Subject	Response to Section 22 Notice: Australian Paper EfW Project	Project Name	Australia Paper Energy from Waste
Attention	Andreas Elvin Project Manager – Development Assessments Unit EPA Victoria	Project No.	RO097400
From	Roger Winders		
Date	23 July 2018		
Copies to	David Jettner, Australian Paper

Jacobs has prepared this Memorandum in conjunction with Australian Paper (AP) in response to a request for further information from the EPA via a Section 22 Notice received on 10 July 2018. The EPA has requested that AP provides further supporting information to respond to submissions received by EPA regarding the Works Approval Application (WAA) during the public advertisement period.

Figure 1 : Typical SCR Simplified Process Flow Diagram⁶

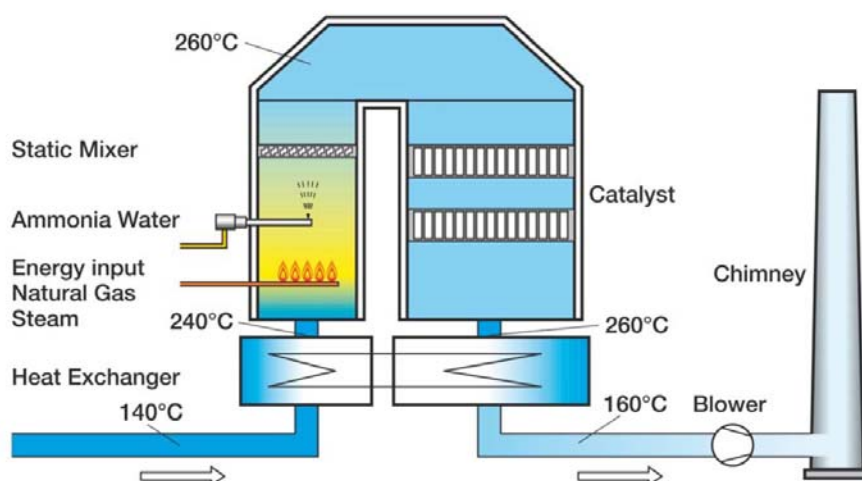
2. Please provide additional evidence supporting the assessment of how Selective Non-Catalytic Reaction (SNCR) can be considered best practice in comparison with Selective Catalytic Reaction. This assessment must clearly outline best practice in terms of environmental, economic and social benefits.

The optimal temperature range for the catalytic reduction process that is generally adopted for SCR systems for EfW is around 230 to 320°C⁷ to maximise the conversion of NO_x to N₂ and minimise ammonia slippage to the flue. As reported in the WAA, the flue gas temperature after the bag filter system is expected to be around 140°C. For the purposes of avoiding poisoning of the SCR catalyst with dust and other gas contaminants, it is standard practice for EfW plant employing SCR to install the catalysts after the bag filter cleaning system⁷ as shown in Figure 1.

This operating temperature requirement adds considerable complexity to the energy recovery process, and necessitates reheating the flue gases after the bag filter before entry to the SCR process, and then, where possible, recovering some (but not all) of this heat back through a heat exchange process.
